Delaware County Regional Sewer District

# **NFPA 820 COMPLIANCE REPORT – SR, TF, LS WRF ONLY**

Analysis of Facilities and Pump Stations

April 23, 2018

Photo 25: Lower Scioto WRF - Sample Room Plan

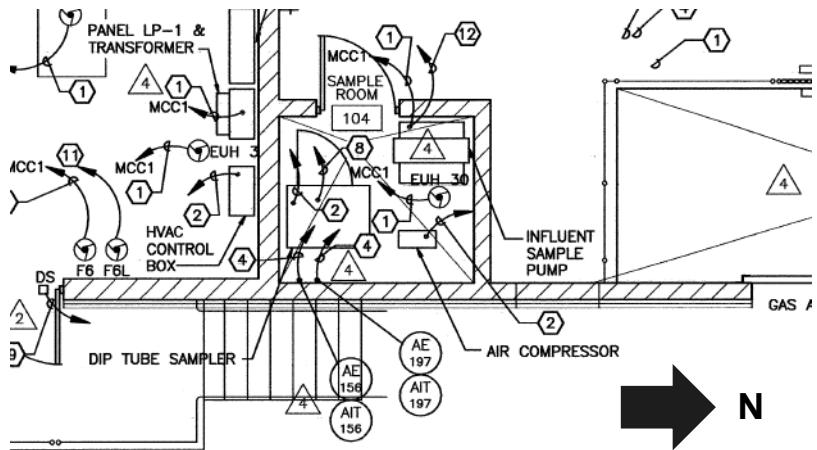
A sample room is located in the southeast corner of the screening area. The sample room has a single door that connects to the screening area. As the screening area is rated as Division 2, the sample room is also rated Division 2, due to the connecting doorway. None of the equipment nor devices installed within the sample room are rated for installation in a Division 2 area.

There are a few possible solutions for this situation. One would be to replace all the equipment and devices with items rated for installation in a Division 2 area.

Another would be to close off the existing door and create a new door into an adjacent space. To isolate the sample room the door on the west wall to the screen room would be demolished and the opening filled. A new door would be required to the south or the east. A door to the south would require relocation of several control panels and conduits mounted on the other side of the wall in the blower section of the building. Some of the equipment within the room would also need to be rearranged to accommodate the new entrance.

To add a door in the east wall would require modification of the stairs and platform for entry to the blower side of the building. The floor of the sample room is several feet above grade level. Currently the end of the stairs to the blower area are located to the east of the sample room. The existing stairs would need to be removed and the platform extended. New stairs would be needed for the combined platform. The stairs likely would need to be run down the east side of the platform to avoid interference with the rollup door access to the screen room. This would extend into the parking area for the building and push the vehicles towards the roadway. Additionally, some equipment within the sample room would need to be rearranged to coordinate with the new entrance.

Alternatively, continuous positive pressure ventilation could be provided to the sample room as described in section 3.5.3.1.2 below. The requirements of NFPA 496, Standard for Purged and Pressurized Enclosures for Electrical Equipment, for Type Z pressurization would be followed to allow the use of unclassified equipment in what would otherwise be a Division 2 environment. Type Z pressurization must be monitored and alarmed (similar to ventilation systems for derating an area). With Type Z pressurization the equipment in the room does not need to be de-energized upon a failure of the pressurization system.

Photo 30: Lower Scioto WRF – Exhaust Fan F-18

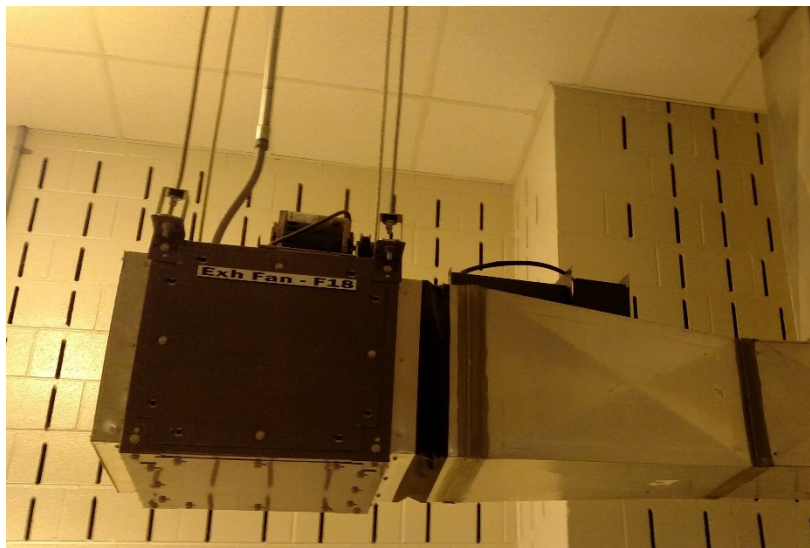
Currently the inline exhaust fan located in the Sludge Room, F-18, is installed with a screened intake on the end of the fan. As installed the ventilation only encourages exhausting air from the mid-level of the room and neglects the upper and lower levels. It is also recommended that the ductwork be added to the end of the fan and extended up to the ceiling and down to within a foot of the floor to scavenge from all areas of the room.
